Technical Memorandum

To: Frank Sowers, P.E., NYSDEC Region 8
From: Lu Engineers
Date: 9/4/09
Project: Former Churchville Ford: Site #V00658-8

Re: Remedial Action Work Plan Addendum; Proposed Additional Injection Well
Lu Project No.: 5701-11

FIGURE 1.
INJECTION WELL DETAIL

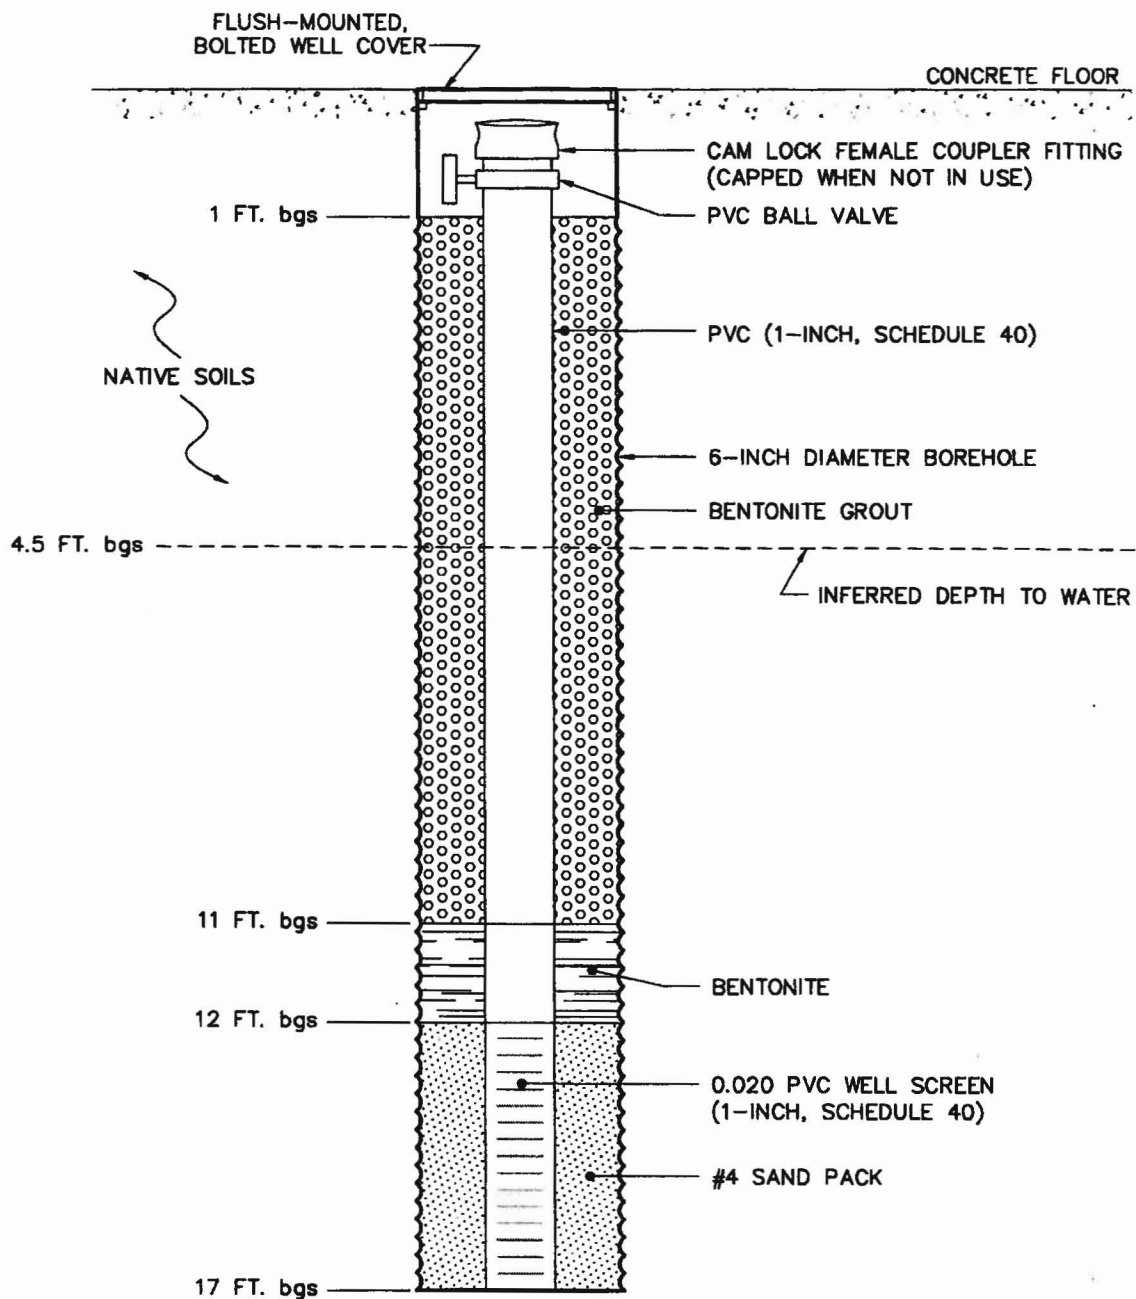
As discussed with NYSDEC, Lu Engineers has installed a deeper injection well within the source area to complete the injection process by more effectively dispersing the permanganate material into the subsurface during each remaining injection event. This new injection well will also serve to accept more permanganate than the wells installed to date and the monitoring wells used as injection points. The new injection well will accept the planned volume of permanganate, which would have been injected at the site monitoring wells. The new injection well's location within the source area will also provide more direct and effective access to the highest contaminant levels, and thereby expedite the remedial process.

Figure 1 illustrates the well construction detail for the proposed additional well while Figure 2 indicates the new well location within the source area. The well design is consistent with the injection wells outlined in the approved RAWP but screened at a deeper interval. As indicated on Figure 2 the deep injection well was installed in the source area adjacent to monitoring well MW-JCL-2.

The new injection well is screened from 17 to 12 feet below ground surface with a one foot thick bentonite seal and grouted to within one foot of the ground surface. This leaves sufficient room for the appropriate cam-lock completion for connection to the approved Geoprobe GS-2000 injection pump. Through use of this deeper injection well, the permanganate solution can be more effectively introduced in the contaminant source area to allow for enhanced vertical and lateral dispersion of the permanganate solution and to complete the injection process. Lu Engineers will continue to gravity-feed monitoring wells MW-1, MW-3 and MW-6 with permanganate solution during each remaining injection event.
